Product Change Notification / CAAN-03WBMN634

CCB 6669 Final Notice: Qualification of MTAI as a new scan and pack site for selected CAP1293 and CAP1203 device families available in 8L SOIC (.150in) package.

CCB 6669
Pre and Post Change Summary
PCN #: CAAN-03WBMN634

Carrier Tape

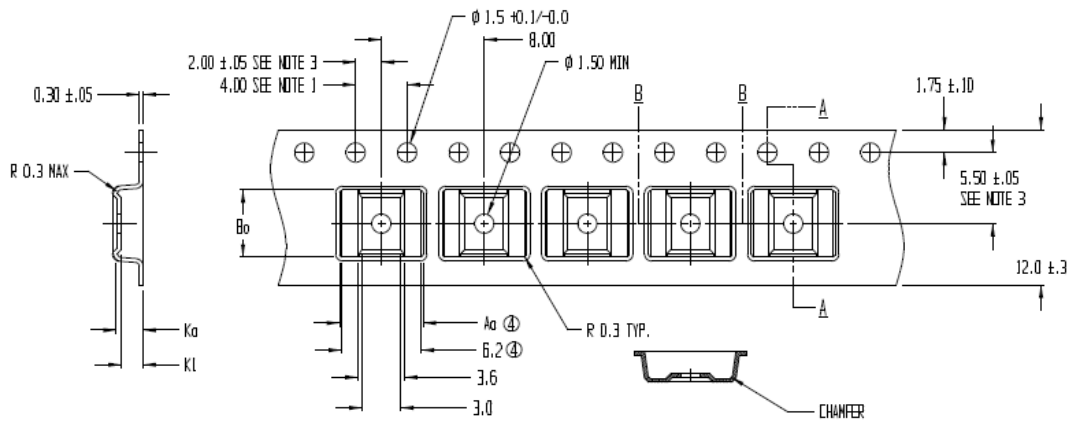
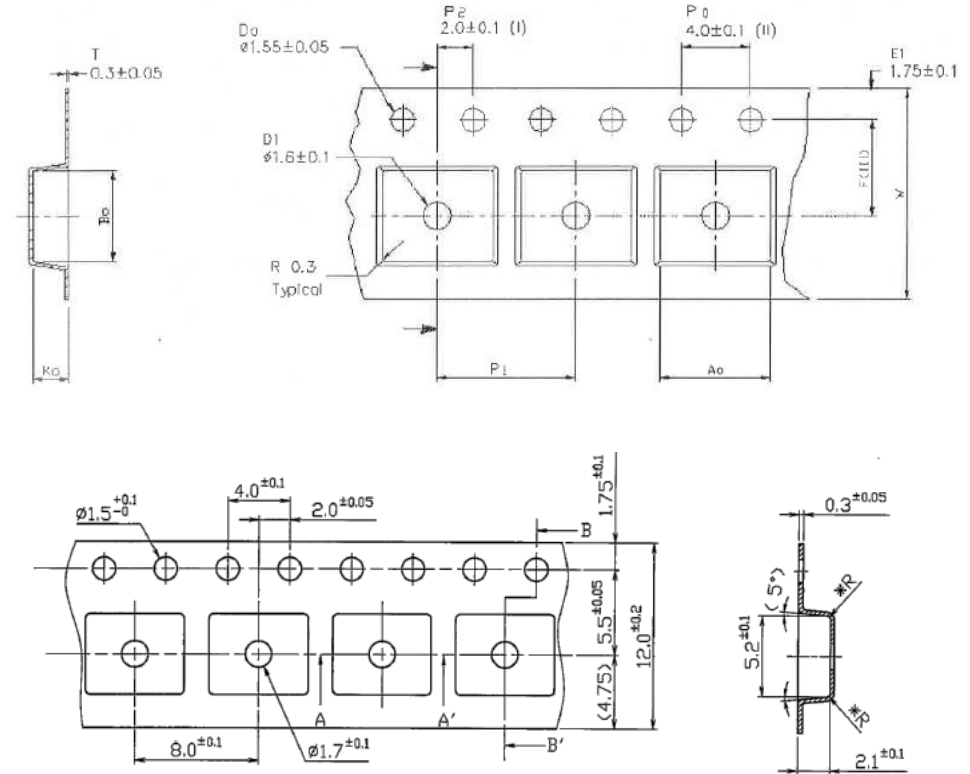
Plant	W (mm.)	P (mm.)	A0 (mm.)	B0 (mm.)	K0 (mm.)	K1 (mm.)	Thickness
MTAI	12.00 ±0.30	8.00 ±0.10	6.40 ±0.10	5.20 ±0.10	2.10 ±0.10	-	0.30
SIGT	12.00 ±0.30	8.00 ±0.10	6.50 ±0.10	5.20 ±0.10	2.10 ±0.10	1.70 ±0.10	0.30±0.05

Cover Tape

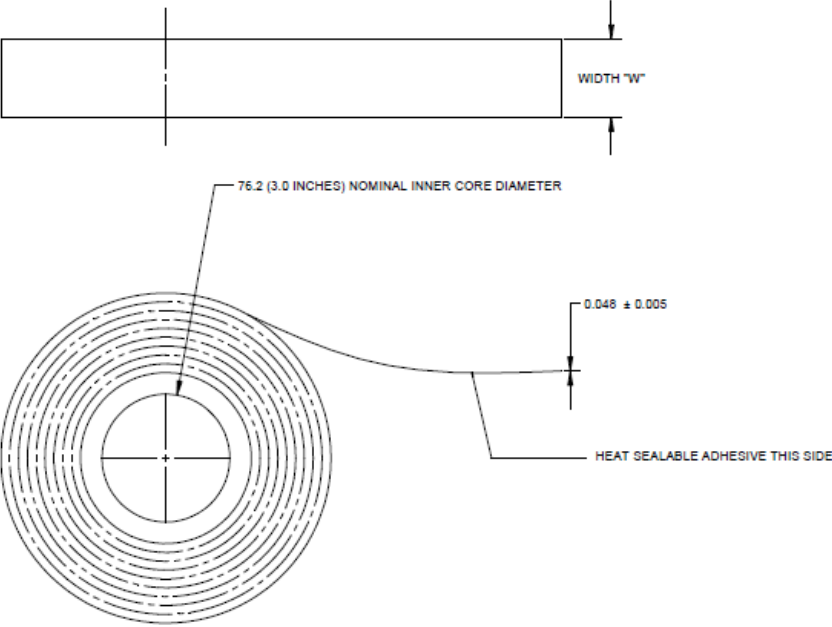
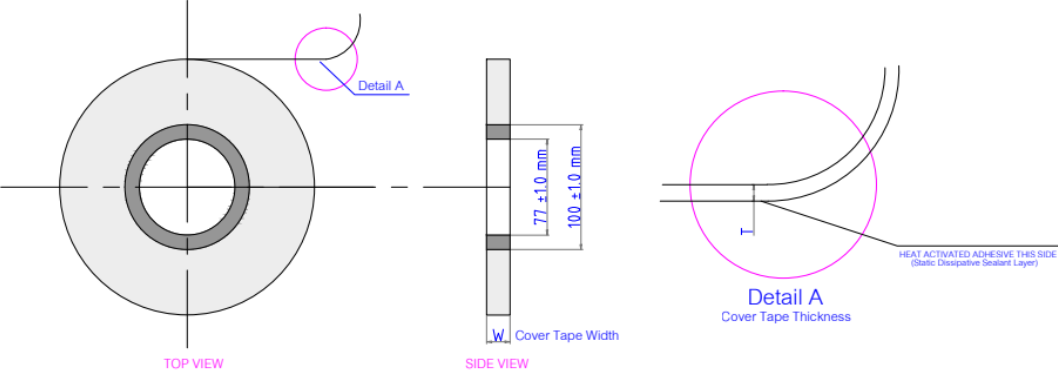
Plant	Width W (mm.)	Thickness T (mm.)	Color	Sealing Methodology
MTAI	9.05 +0.05/-0.15	0.050 ±0.010	Clear	Heat Seal
SIGT	9.20 ± 0.10	0.048 ±0.005	Clear	Heat Seal

Plastic Reel

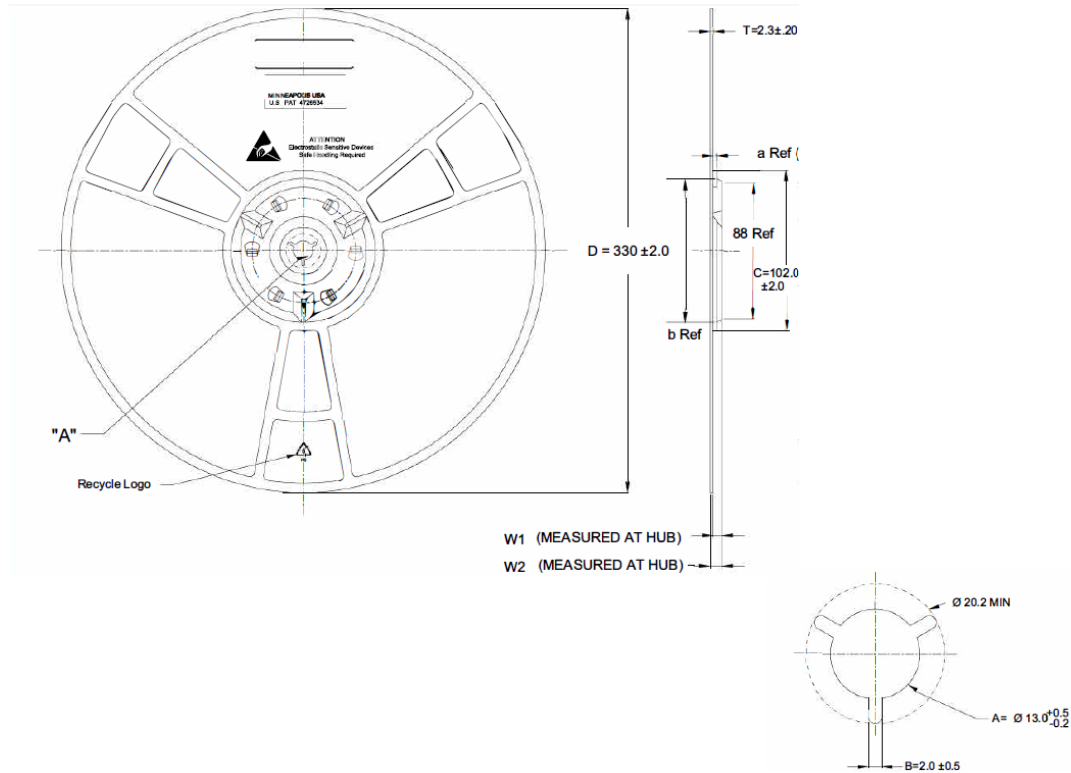
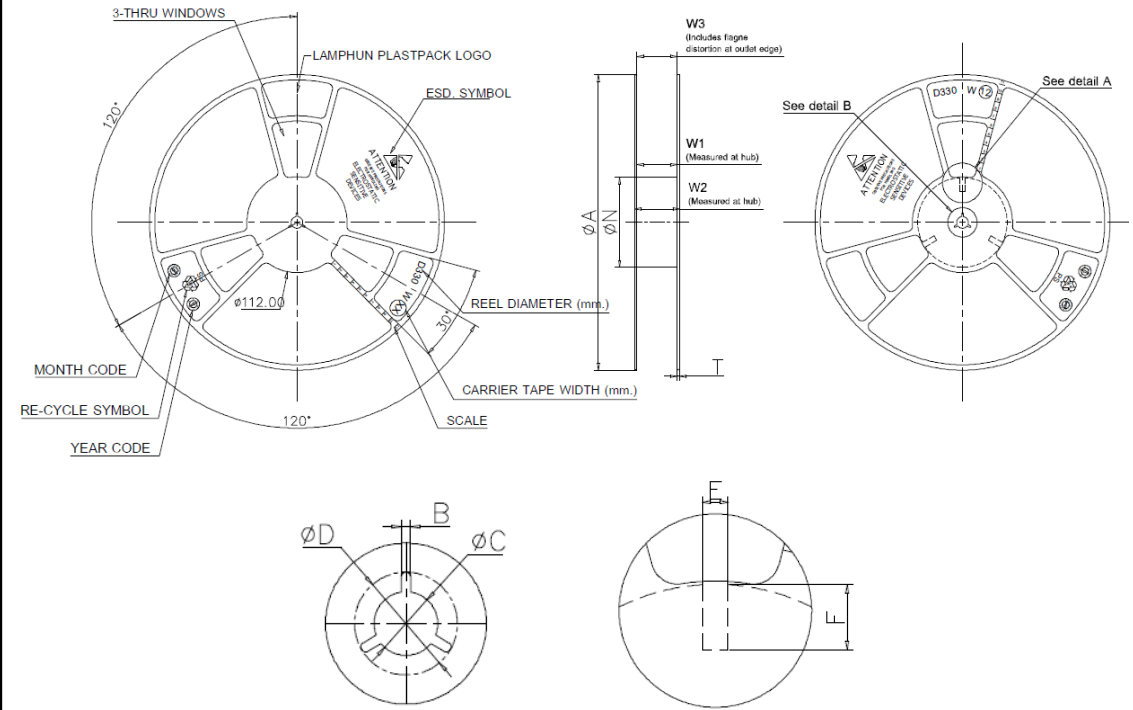
Plant	Reel Diameter (mm.)	Reel Hub Size (mm)	Reel Width Max (mm.)	Color
MTAI	330 ± 2.0	100 ± 2.0	18.40	Dark Blue
SIGT	330 ± 2.0	102 ± 2.0	18.40	White

Packing Method

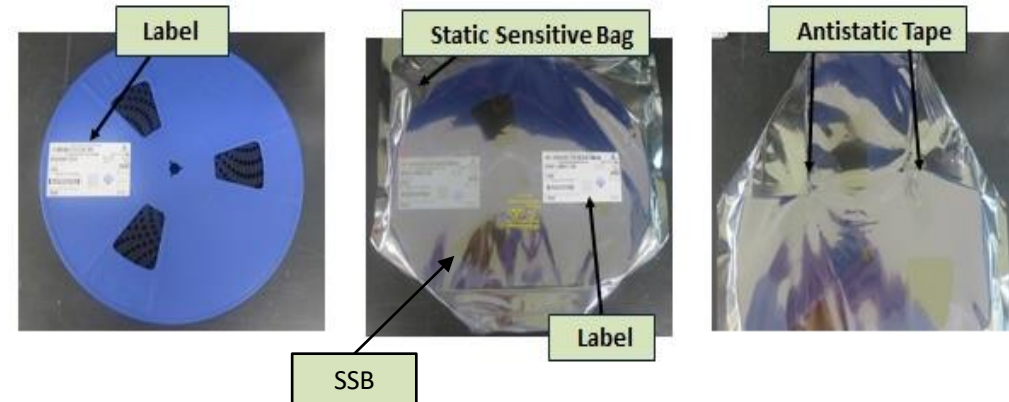
BAG WIDTH	BAG LENGTH
370 mm	420 mm

Carton	Dimension W x L x H (cm)	Number of reel per carton
		Reel diameter (D) = 330mm
		Carrier Tape Width 12mm
M01-011 (TT)	36.5x38x39.5	15
M01-012 (B1)	35.5x35.5x2.8	1
M01-013 (B2)	35.5x35.5x4	2
M01-014 (B3)	35.5x35.5x6	3
M01-015 (B8)	35.5x35.5x16.5	8
